**DOCUMENT 00 90 00**  
**ADDENDUM**

**ADDENDUM No.:** 2

**RE:** HOUSING AUTHORITY OF THE CITY OF LA CROSSE  
2024 SMOKE ALARMS  
LA CROSSE, WISCONSIN 54601  
PROJECT NO. 24034

**3** 2ND - 7TH FLOOR SMOKE ALARM PLAN  
1/8" = 1'-0"

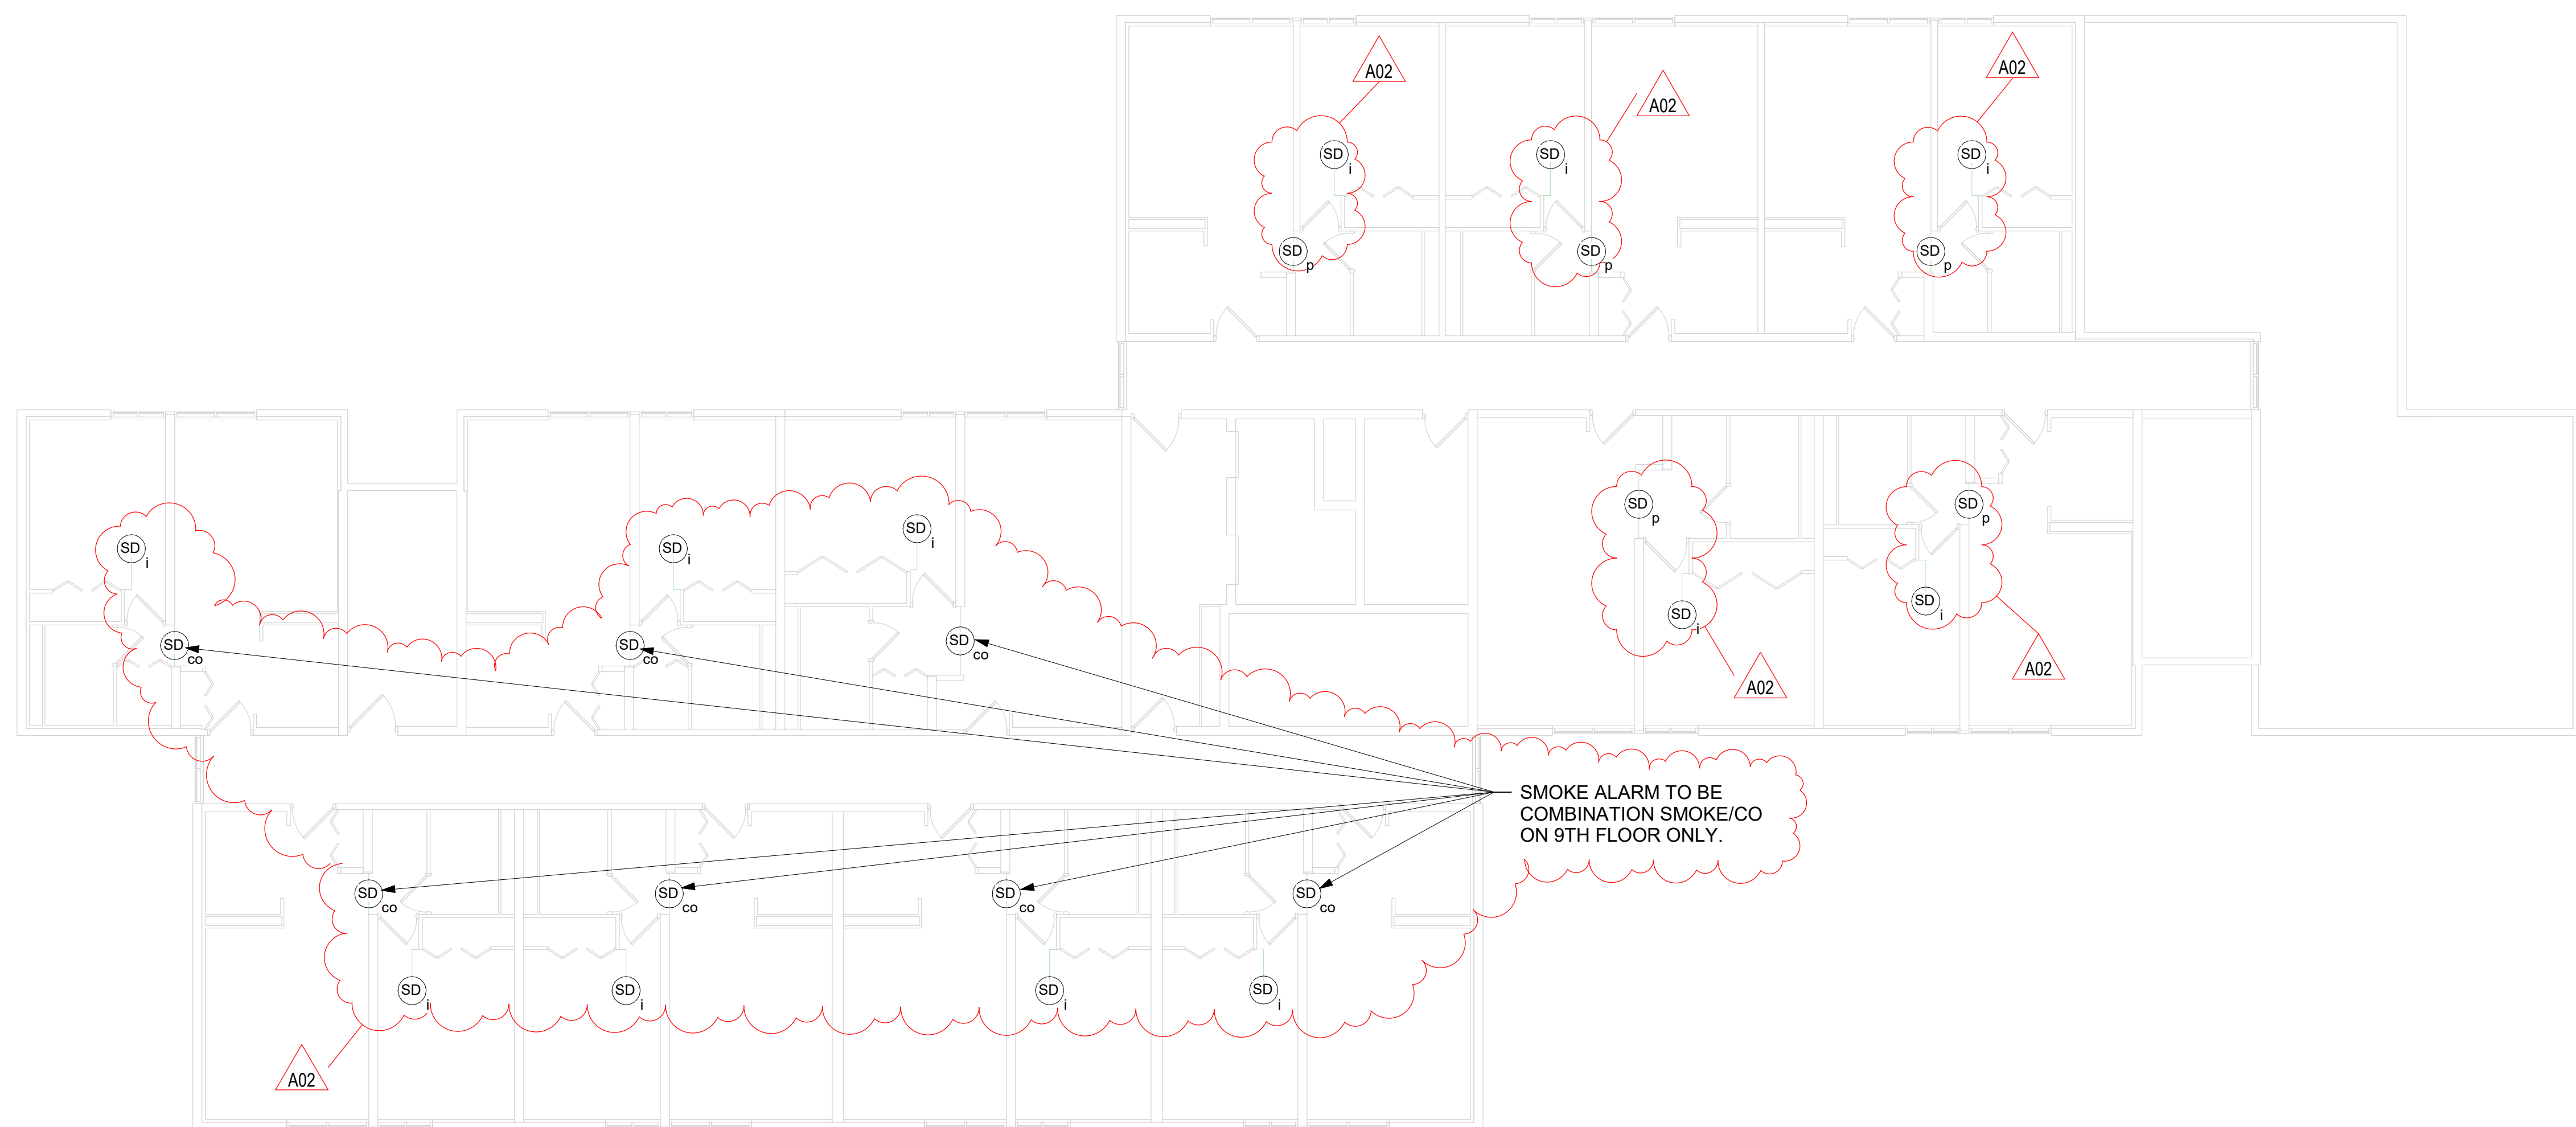
### 6. Sheet E201 SMOKE ALARM UNIT PLAN 30"x42"

- a. See the revised sheet included in this addendum. Disregard the previous version.
- b. Revised sheet to reflect a changed approach from wired smoke alarms to wireless. See clouded changes for requirements.
- c. Added notes regarding removal of existing equipment and smoke alarm selection in proximity to fuel-fired equipment.
- d. Revised clouded plan views to remove wiring and conduit.
- e. Added photo to show an example unit interior.

**IF REMOVING ANY HARDWIRED DEVICE WITHOUT INSTALLING NEW DEVICE ON JUNCTION BOX, CAP ALL WIRES AND ADD DECORATIVE BLANK COVER TO JUNCTION BOX TO COVER OPENING TO FINISHED SURFACE. BASIS OF DESIGN IS: ARLINGTON #CP3540, OR EQUAL.**

E401

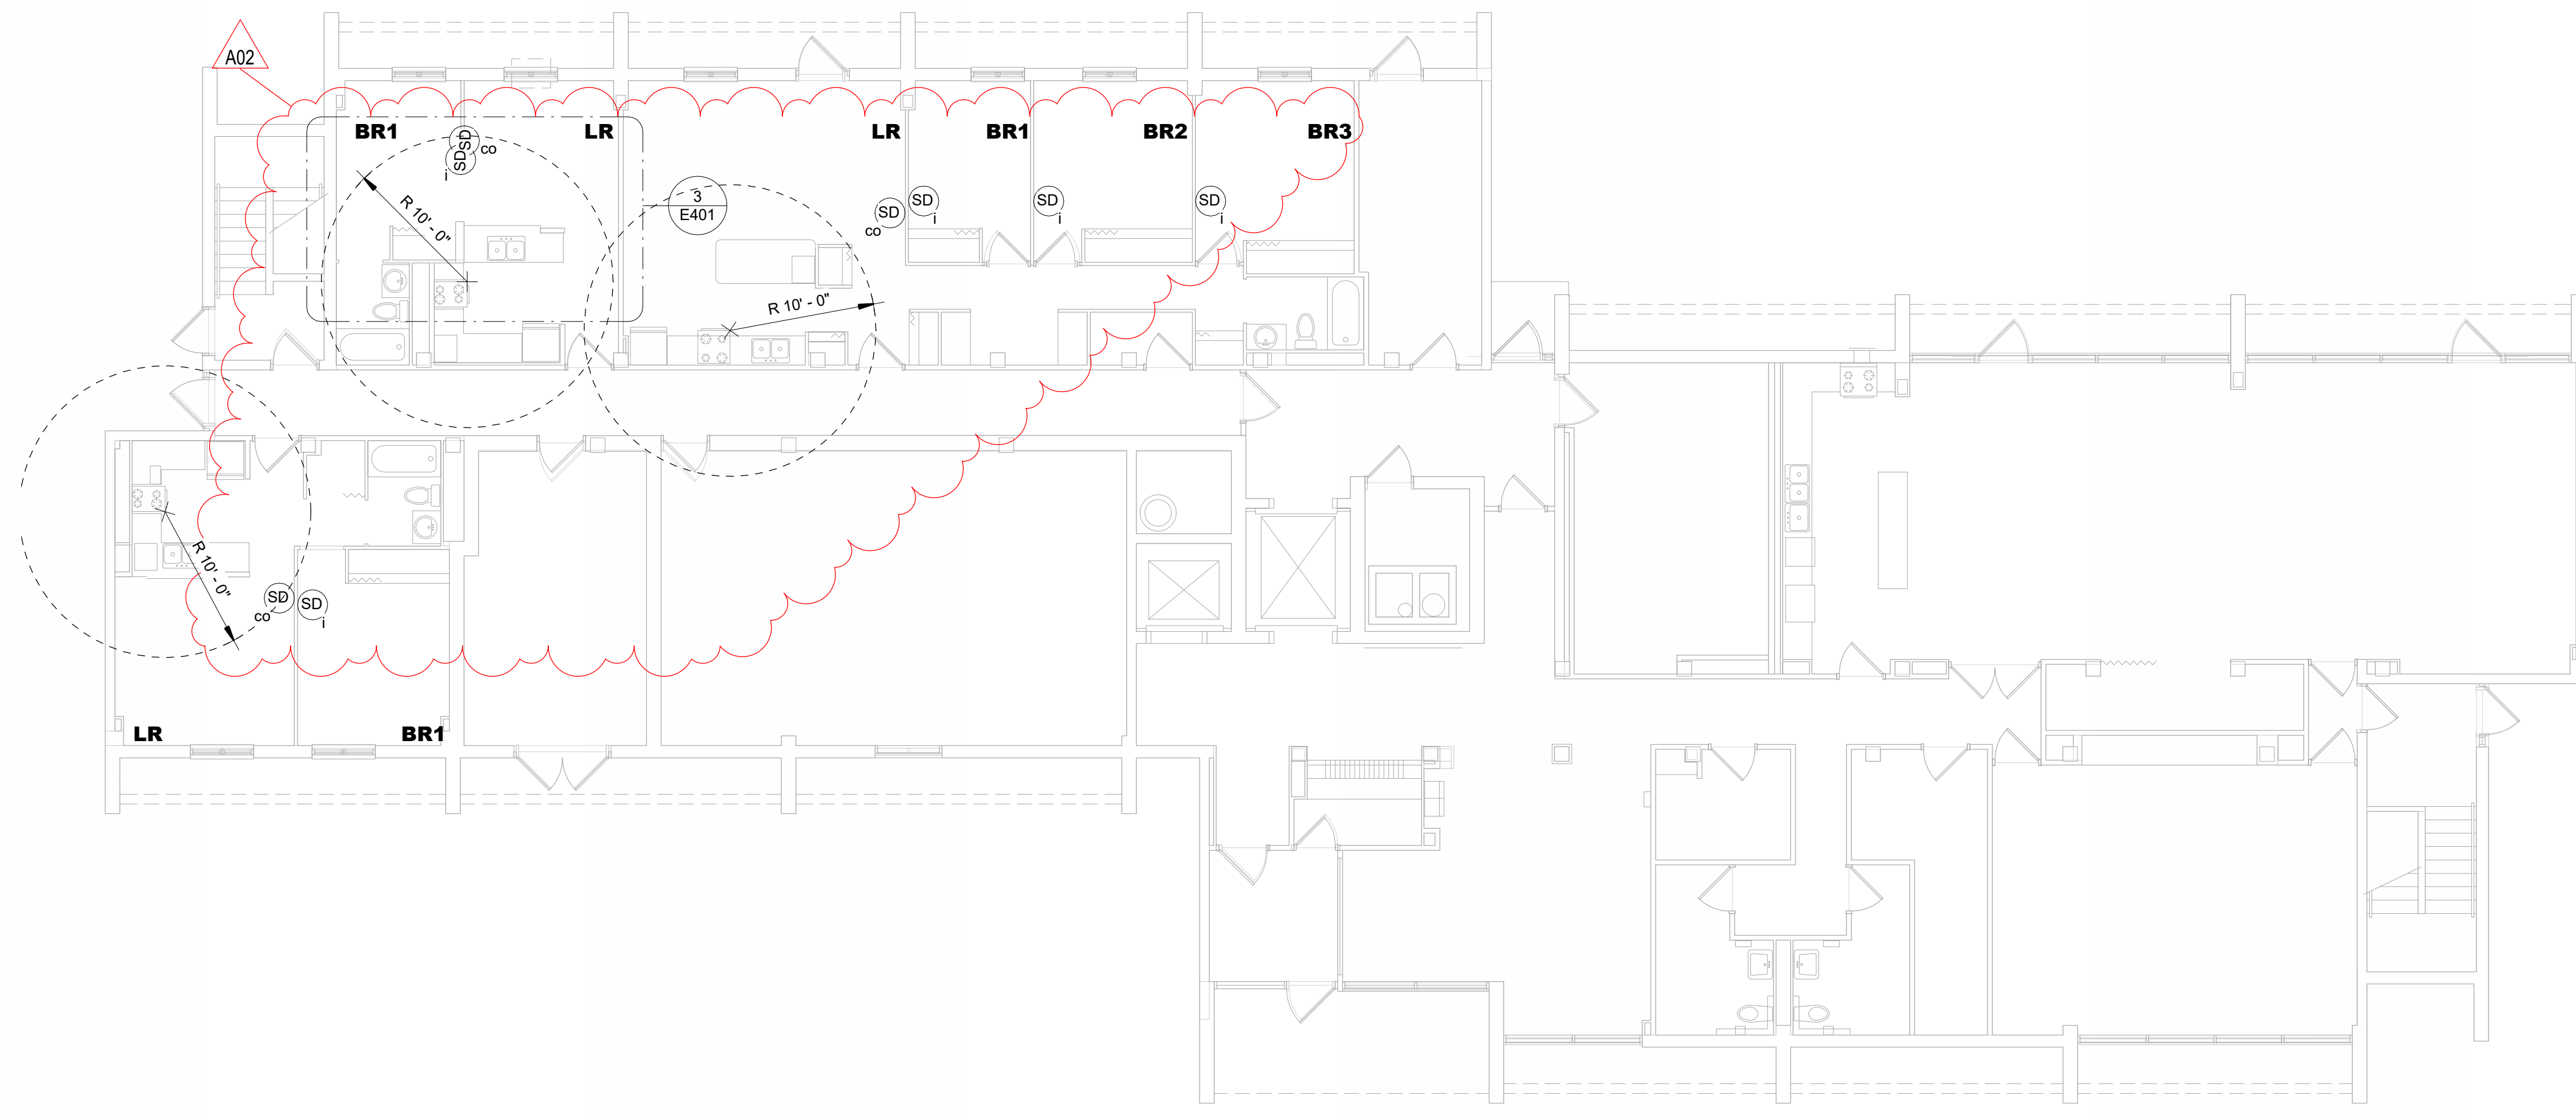
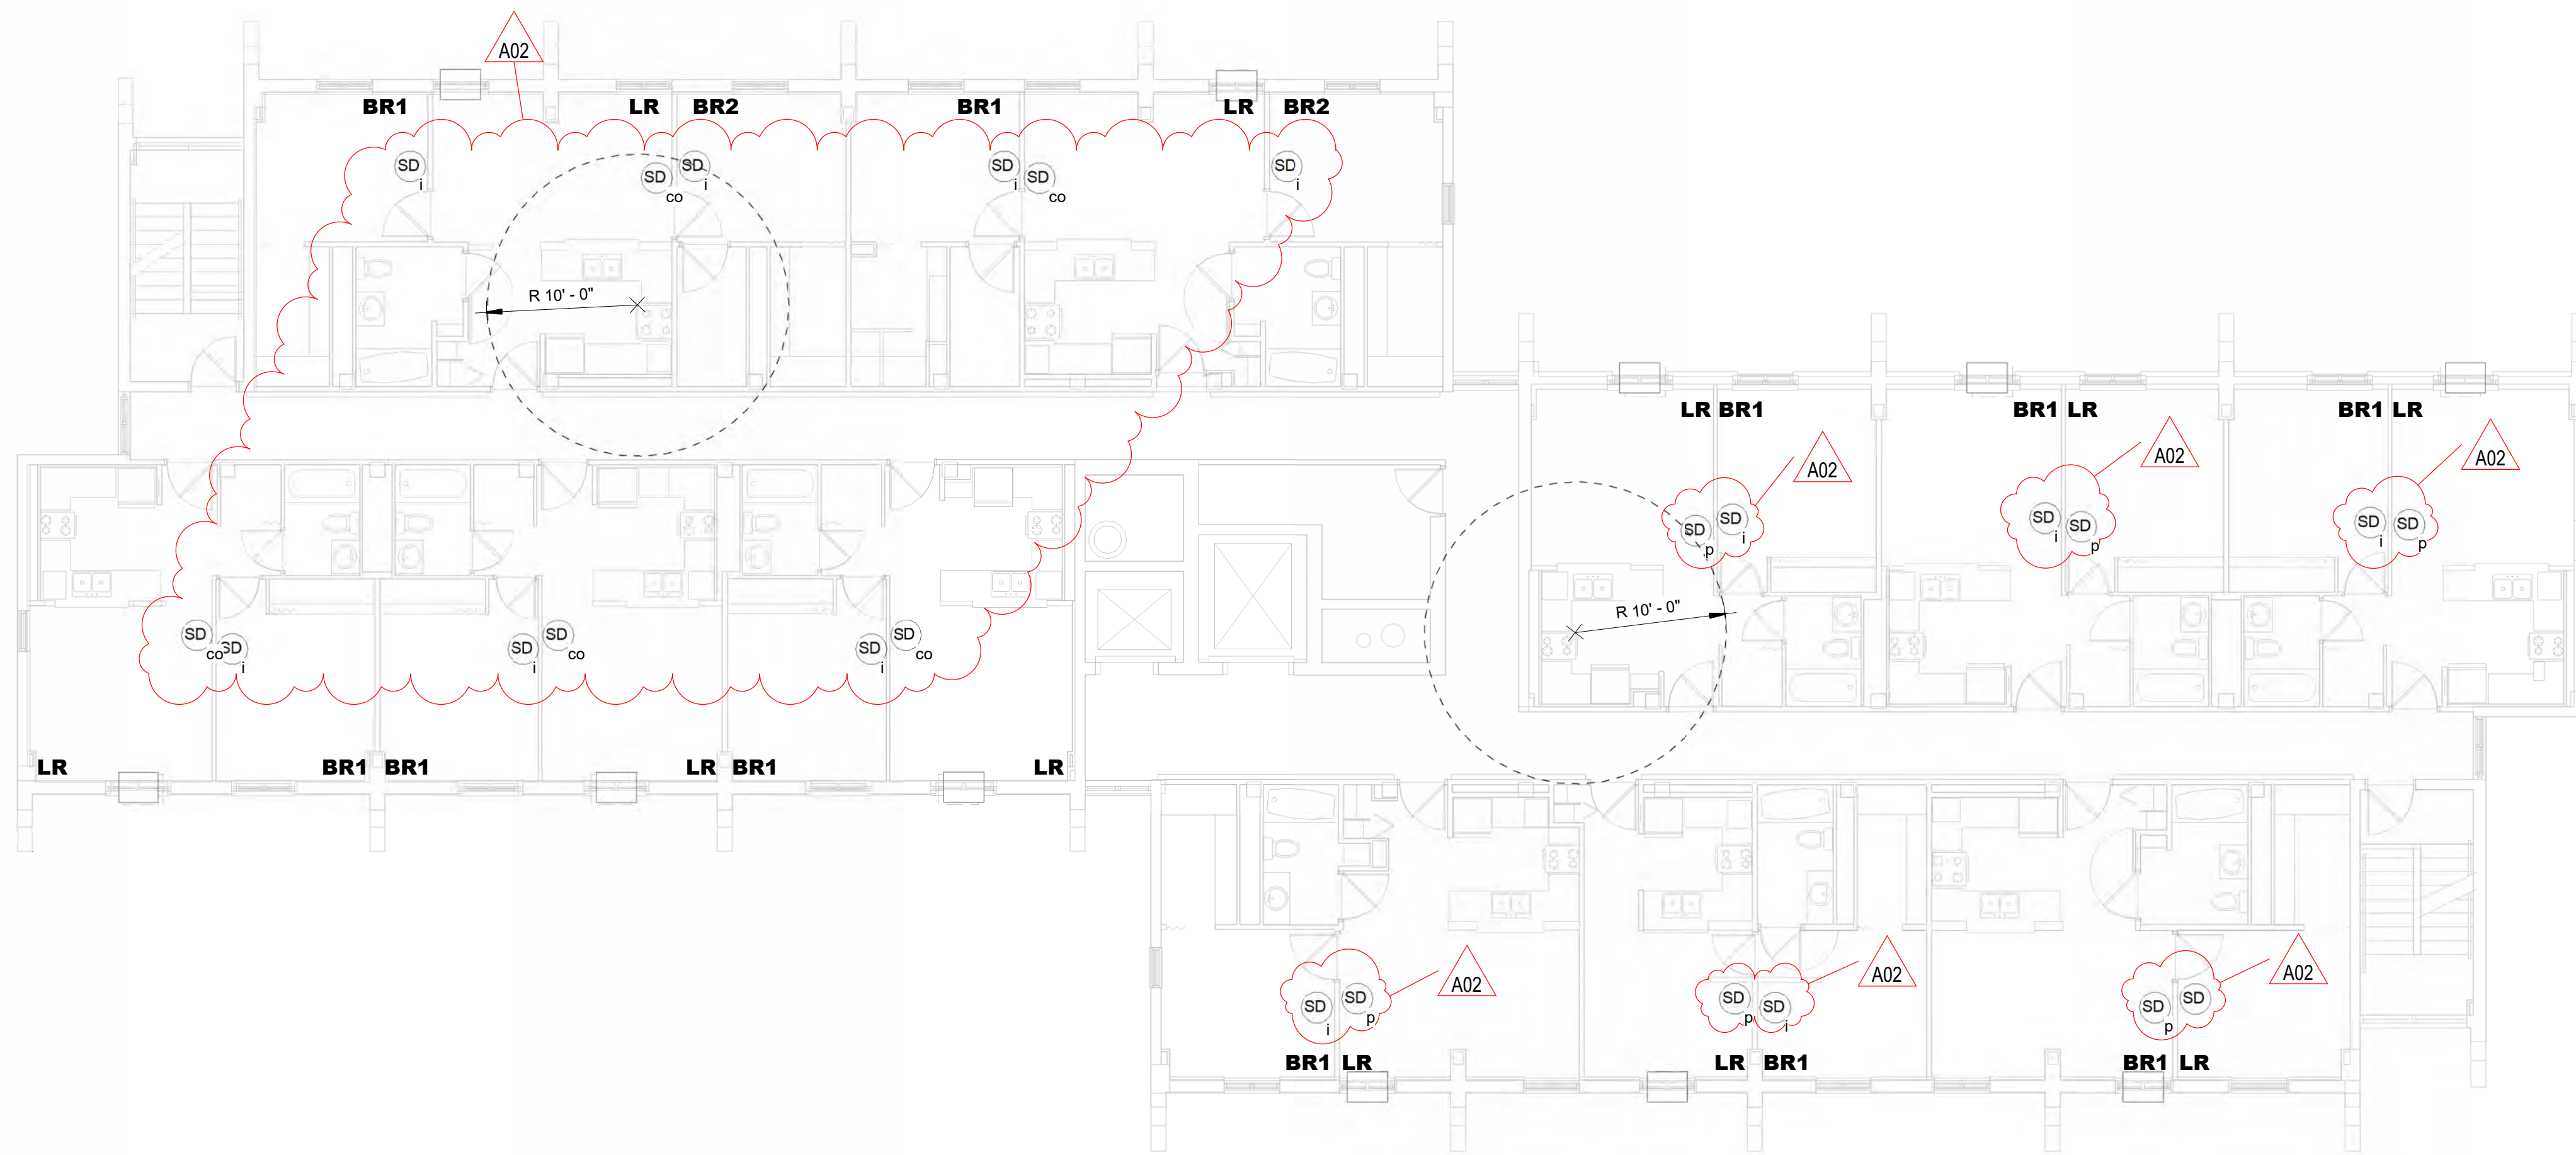
- c. Revised clouded plan views to remove wiring and conduit.
10. Sheet E401 SMOKE ALARM UNIT PLANS 30"x42"
  - a. See the revised sheet included in this addendum. Disregard the previous version.

- b. Revised sheet to reflect a changed approach from wired smoke alarms to wireless. See clouded changes for requirements.
  - c. Added notes regarding removal of existing equipment and smoke alarm selection in proximity to fuel-fired equipment.

- d. Revised clouded plan views to remove wiring and conduit.
  - e. Added photos to show an example unit interior.
  - f. Added diagram showing radius of cooking zone.

ANY APARTMENT UNIT LOCATED ON THE FLOORS ABOVE AND/OR BELOW A MECHANICAL ROOM WITH FUEL-FIRED EQUIPMENT IS REQUIRED TO HAVE A COMBINATION SMOKE/CO IN EVERY APARTMENT UNIT AS SHOWN.
